Meeting Minutes Transmittal/Approval
Unit Managers' Meeting
Remedial Action and Waste Disposal Unit/Source Operable Unit
3350 George Washington Way, Richland, Washington
April 1999

**MEETING MINUTES
REMEDIAL ACTION AND WASTE DISPOSAL
UNIT MANAGERS' MEETING -- 100 AREA
April 22, 1999**

**Test Plan for the Determination of Distribution Coefficient and Leachability of
Hexavalent Chromium in 100 Area Hanford Formation Soils.**

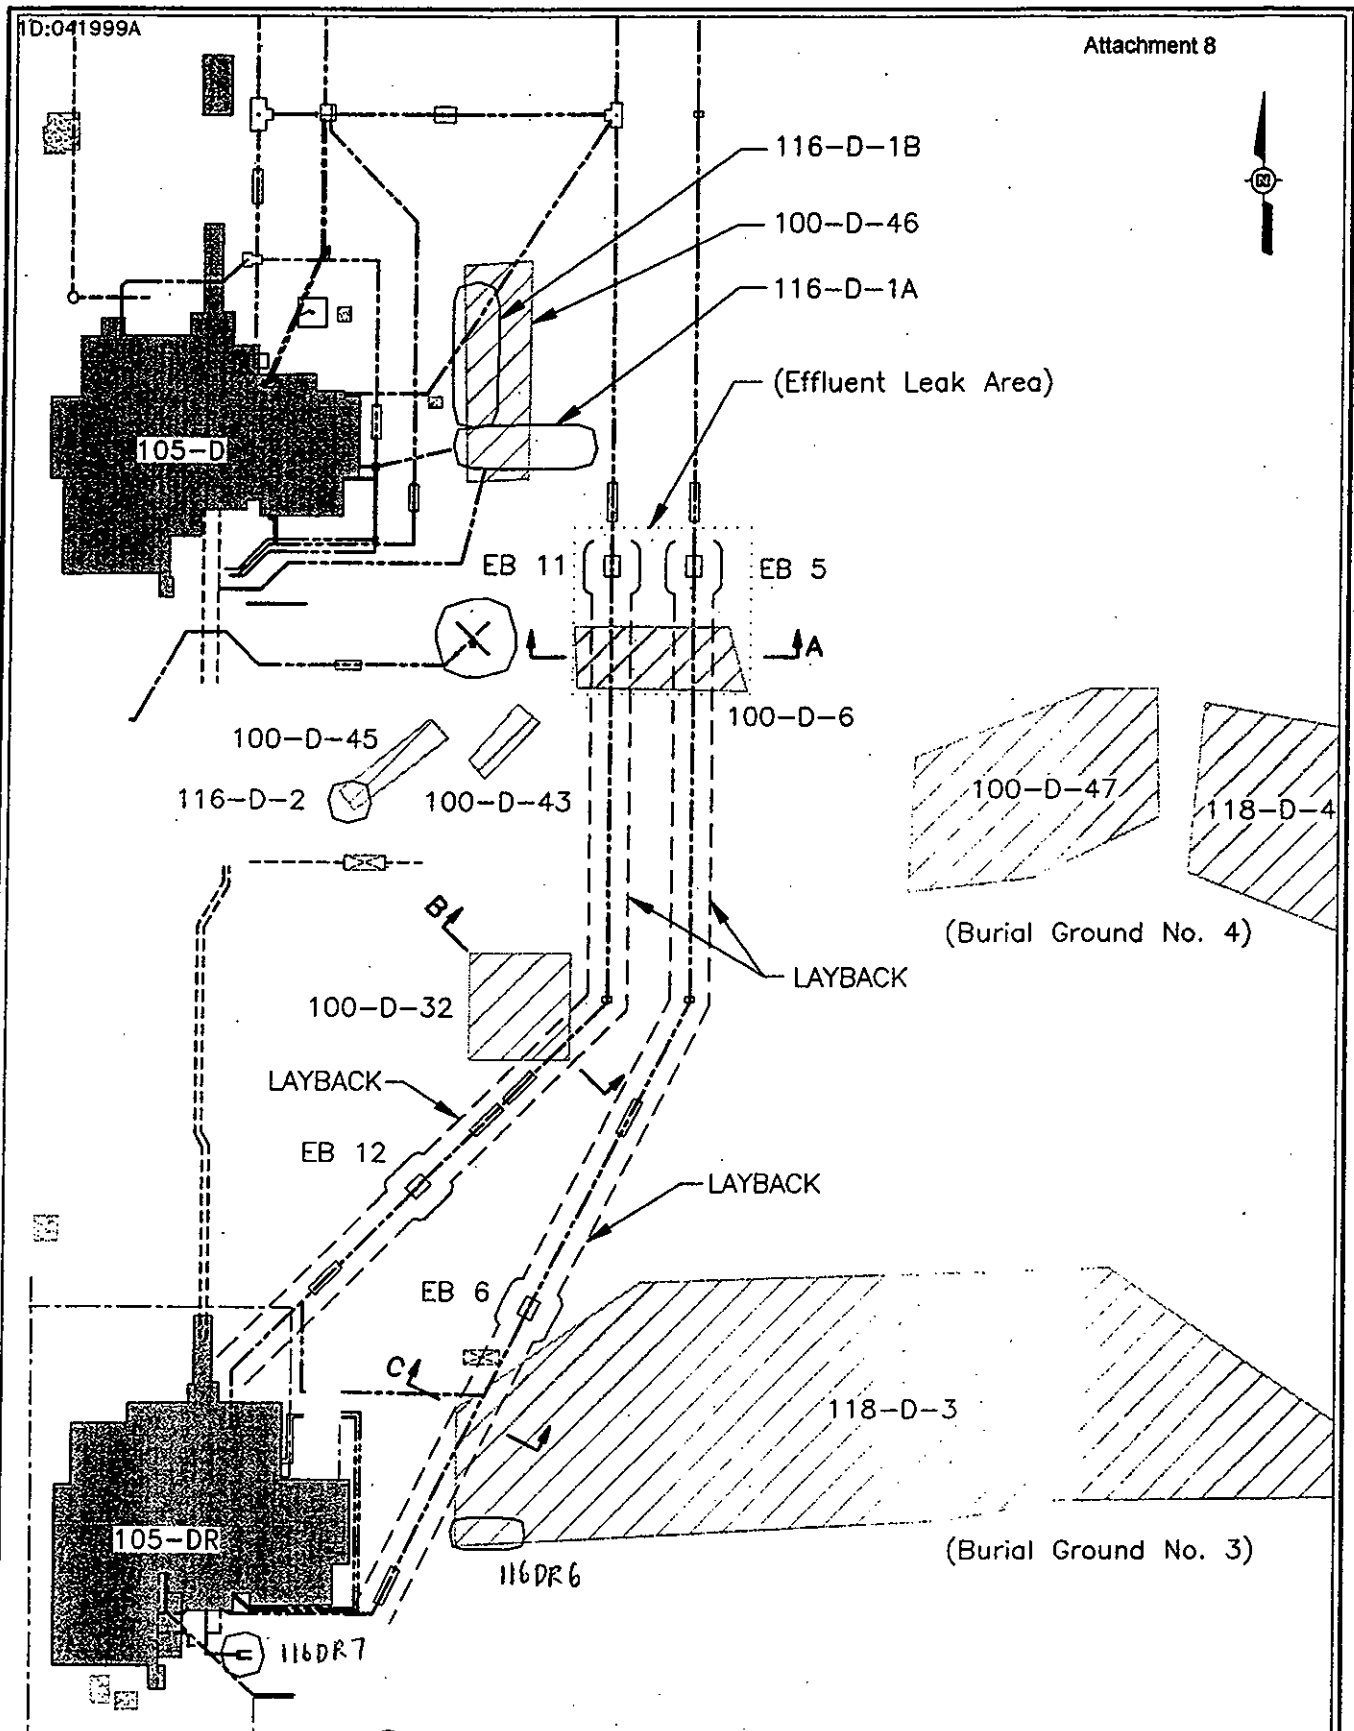
29. p. 13, 3.0, para. 2: But it is not the chemistry of the water that may leach contaminants of concern from the soil.

Response: **Noted:** See comment # 19. Further rainwater quickly equilibrates with the arid Hanford sediments and takes on the chemical nature of the pore water and thus the groundwater. No change in text or test plan will be made.
